AGENDA
THE HAMILTON COUNTY RURAL ZONING COMMISSION
REGULAR MEETING

STAFF REPORT

MIAMI 2015-01

MIAMI HEIGHTS SQUARE

LAND USE PLAN

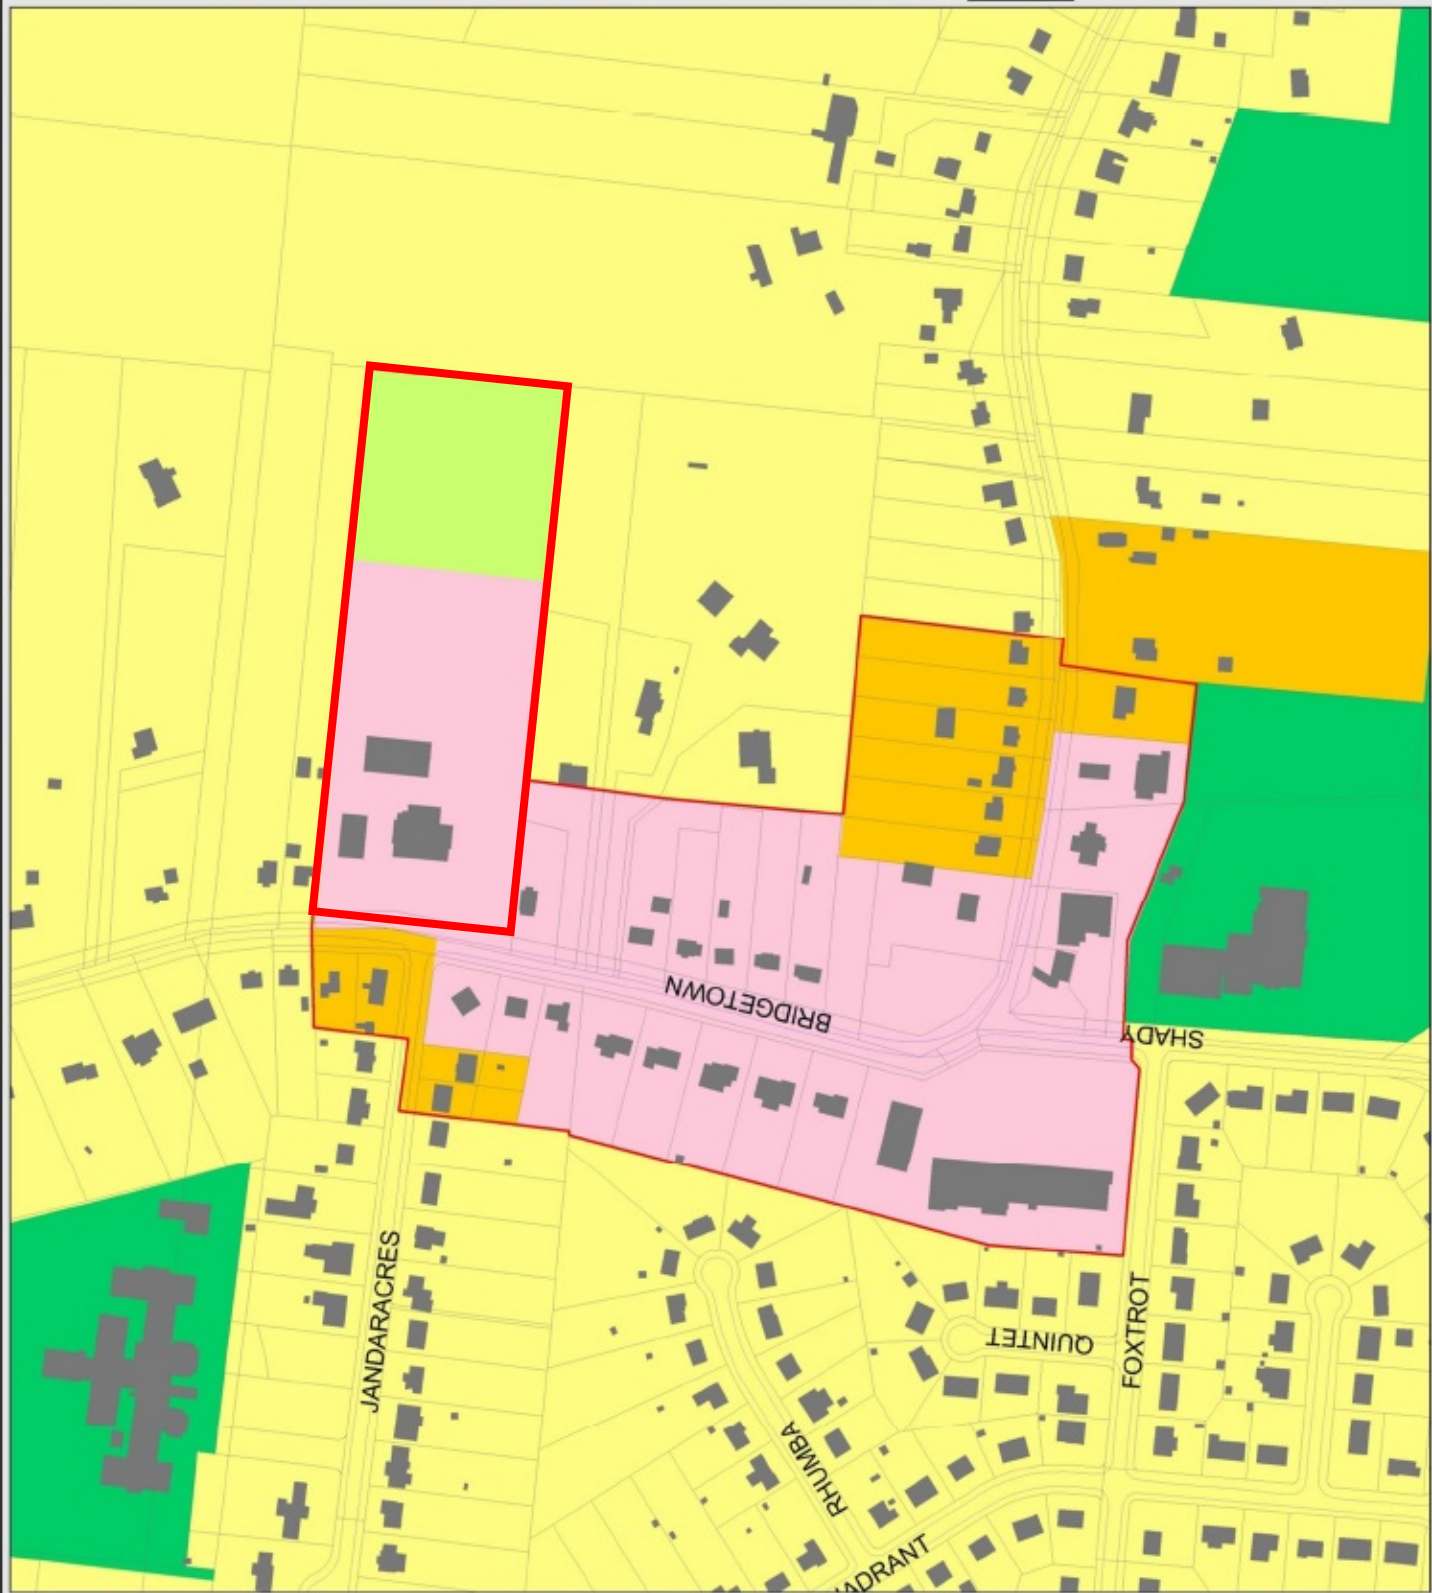
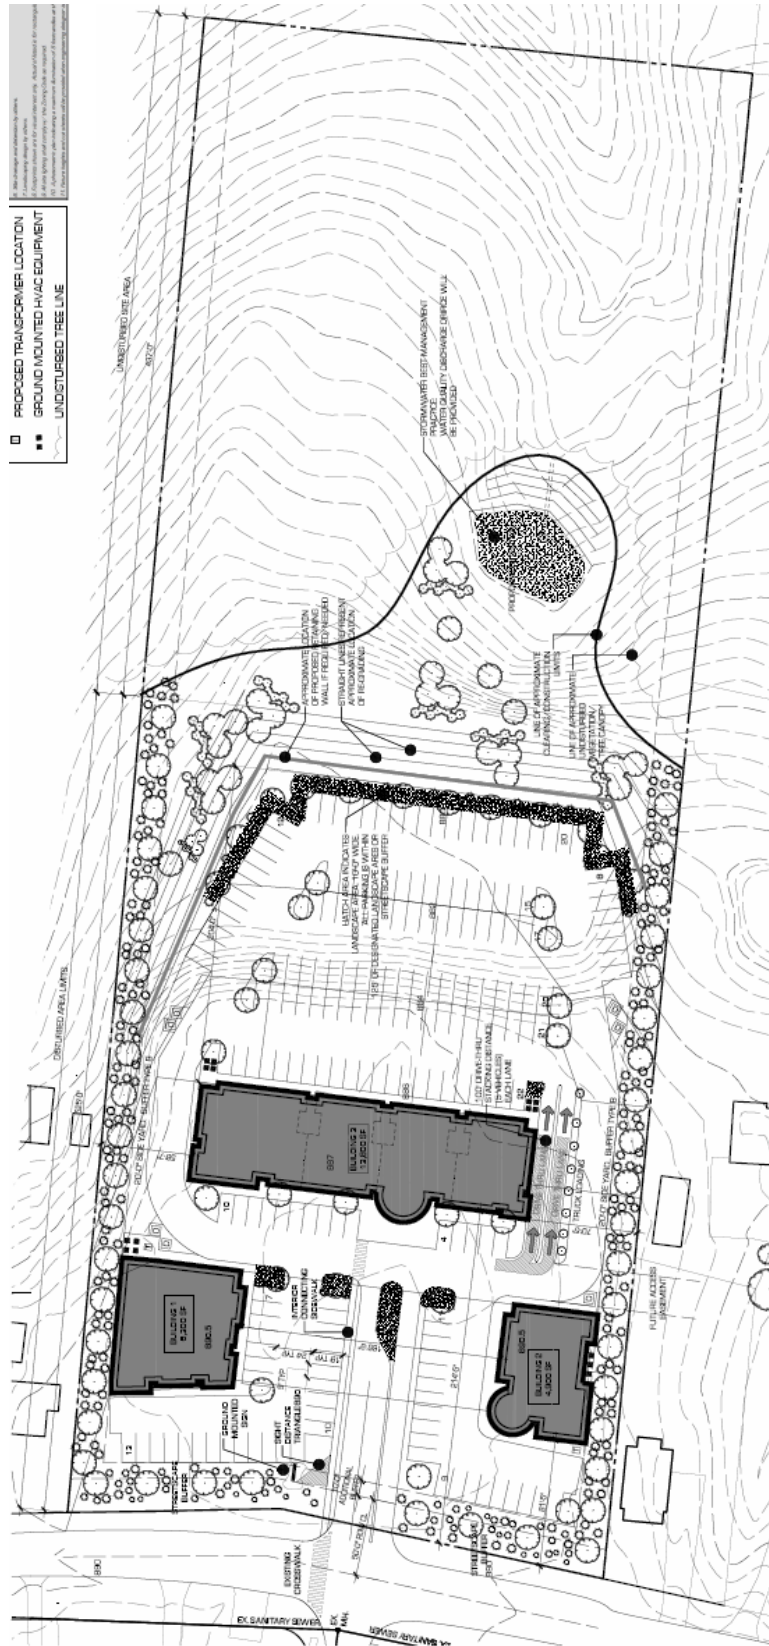
- *The Miami Township Land Use Plan Map designates the front two-thirds of the site along Bridgetown Road as “Neighborhood Retail”, which is defined as low intensity neighborhood oriented retail and service uses that provide a transition between residential uses and other types of development or that achieve compatibility and service appropriate to the adjacent residential neighborhood. Typically one-story structures with a scale, massing, intensity, layout and specifications compatible with site constraints and character of surrounding residential developments.*

- *The Land Use Plan Map designates the rear third of the site as “Green Space & Agriculture”, which is defined as passive activities and related uses that retain the natural features of the environment. Typically forests or wildlife reservations, farms and farm activities and cemeteries.*

- *The applicant is proposing to leave the rear third of the site as undeveloped woodlands in compliance with this designation.*
- *Therefore, with a condition of approval preserving this area as undeveloped, staff finds that the proposal would be consistent with the Miami Township Land Use Plan Map.*
